- Request - Special Use Permit for stand-alone solar array
- Location - 0 Dura Avenue
- Applicant / Developer - Project Beacon, LLC  
5100 W. Central Avenue  
Toledo, OH 43615
- Engineer - Verdantas  
219 S. Erie Street  
Toledo, OH 43604

The staff recommends that the Toledo City Plan Commission recommend approval of SUP25-0010, a request for a Special Use Permit for a stand-alone solar array at 0 Dura Avenue, to Toledo City Council for the following **three (3) reasons**:

SPECIAL USE PERMIT  
TOLEDO CITY PLAN COMMISSION  
REF: SUP25-0010  
DATE: April 10, 2025  
TIME: 2:00 P.M.

# SITE PLAN 1

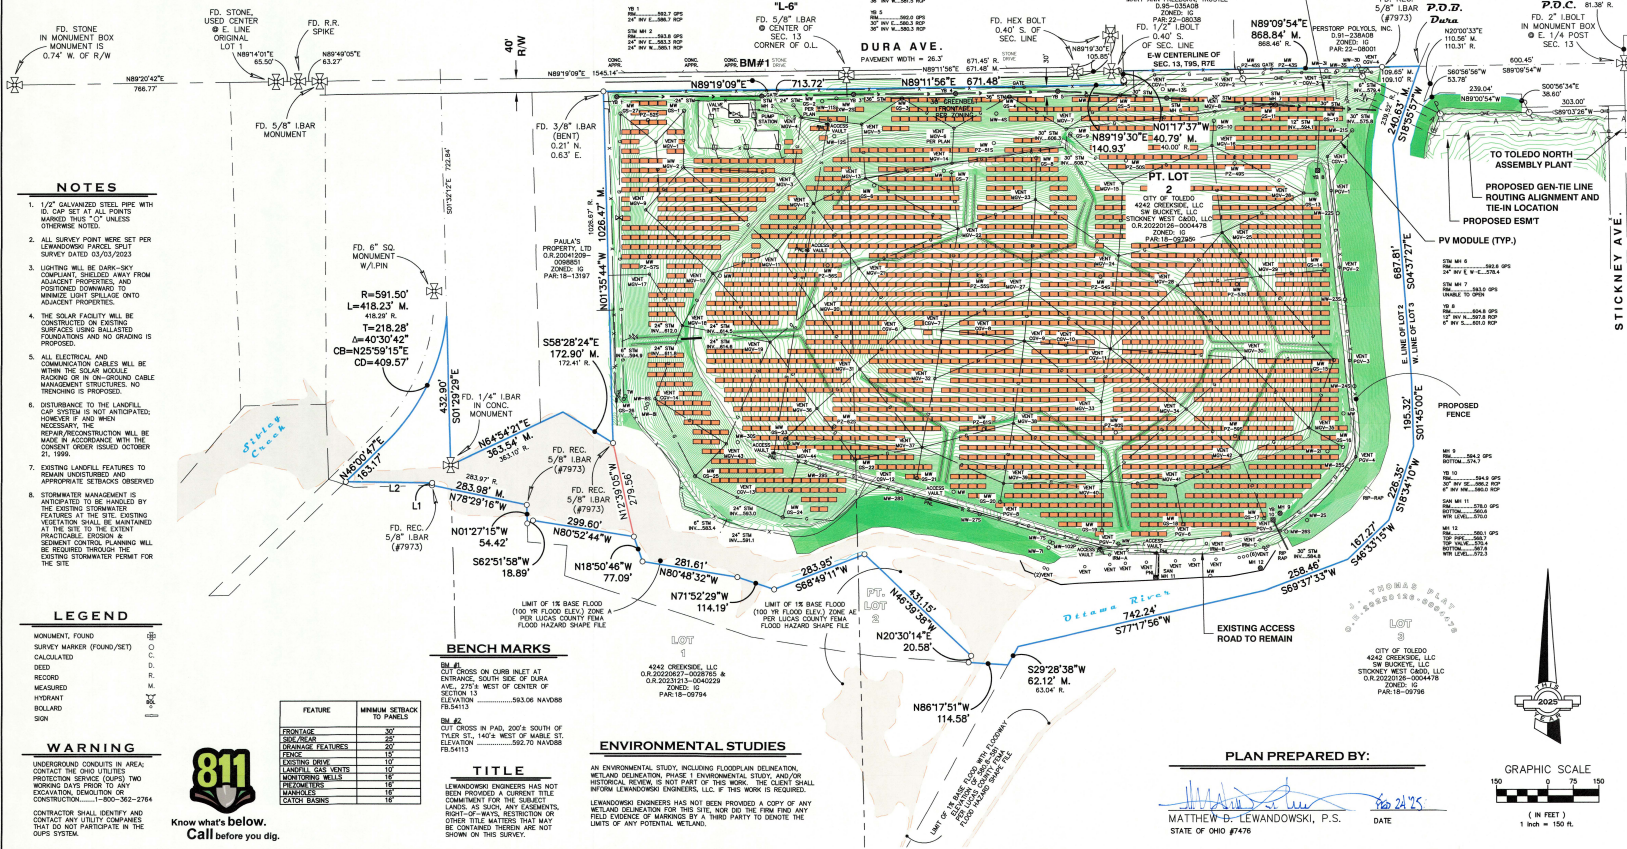
The site plan depicts access roads throughout the site. Per TMC§1107.1906 - Surfacing and Drainage, maneuvering areas, aisles and driveways must be surfaced with concrete, bituminous asphalt, or other dust-free material other than gravel or loose fill, and be graded to drain all surface water towards the interior of the parking lot. Since the site plan indicates that there will not be any disturbance to the landfill cap system, it is assumed that the access road will not be surfaced with concrete or asphalt. As such, the applicant will need to secure a waiver from this requirement.

Sites over five (5) acres are required to provide a thirty-foot (30') frontage greenbelt along the right-of-way per TMC§1108.0202 - Frontage Greenbelts. The frontage greenbelt shall include at least one (1) tree for every thirty-foot (30') of lot frontage. The submitted site plan depicts a thirty-foot (30') wide frontage greenbelt along Dura Avenue; however, a landscape plan has not been submitted that illustrates the required fifty (50) trees. Staff acknowledges that the site is intended for solar energy generation and trees can interfere with this. The applicant will need to secure a waiver from this requirement.

The site plan submitted depicts a seven-foot (7') Bekaert solidlock game fence, with wood posts and steel posts on the corners/ends, surrounding the solar arrays on all sides. This includes the area along Dura Avenue within the thirty-foot (30') front yard. This material is acceptable on all sides with the exception of along Dura Avenue. The portion of the proposed fence along Dura Avenue shall be constructed of a material approved by the Plan Director as a condition of approval. In addition per TMC§1105.0302(1), fences may not exceed 3½ feet in the front yard for all Industrial zoning districts. In addition it appears that the fence will be electrified, and that a portion of the existing fence, which does not meet fence standards, will remain. Per TMC§1105.0303, the use of barbed wire, razor wire, concertina wire, and electric fences are only permitted in Industrial districts and then only in the side and rear yards when not within 50 feet of a Residential district. Barbed wire, razor wire, concertina wire, and electric fences are also not permitted in the front yard or anywhere along a street right-of-way. The applicant shall secure a waiver to the applicable code sections to allow for the proposed fence height and type in the required front yard along Dura Avenue.

5. A SWP3 submittal is required; note 8 on each sheet of the proposed site plan is insufficient to meet the requirement, since a 513 permit for one of the landfills is the only document that calls out surface water management, and the requirements of the 513 are not known to be to the standards of the Ohio Construction General Permit. Toledo requires a SWP3 for projects over 2,500 square feet of construction activity. Placement of the fill (ballast) would constitute a construction activity. The total disturbance of the project would not just be the footprint of the ballasts however and would also include the remainder of the area that will be disturbed by construction activities, including construction traffic. If any of the site is to experience heavy construction traffic from equipment and will disturb the earth, that would need to be accounted for in the calculation of the total disturbed area. The entire project including the electrical transmission work offsite will need tallied, and if greater than an acre, an NOI will also be need to be submitted and authorized by OEPA.

Approve a waiver so that the proposed access roads for the solar energy facility do not have to be surfaced with concrete, asphalt or other dust-free material. Staff is in support of the waiver as the access roads will have minimal use once the facility is constructed.

Approve a waiver to allow a mix of evergreen trees, large shrubs or other plant material, as approved by the Plan Director, in lieu of the fifty (50) trees required along Dura Avenue. Staff is in support of the waiver as large shade trees may interfere with the collection of solar energy on the site.

Approve a waiver to allow for a seven-foot (7') high fence in the front yard along Dura Avenue. Staff is in support of this waiver due to the nature of the proposed use and the need for site safety and security. Additionally, the adjacent property and the property along the north side of Dura Avenue is zoned and used for industrial purposes.

Approve a waiver to allow for an electrified fence in the front yard along Dura Avenue. Staff is in support of this waiver due to the nature of the proposed use and the need for site safety and security. Additionally, the adjacent property and the property along the north side of Dura Avenue is zoned and used for industrial purposes.
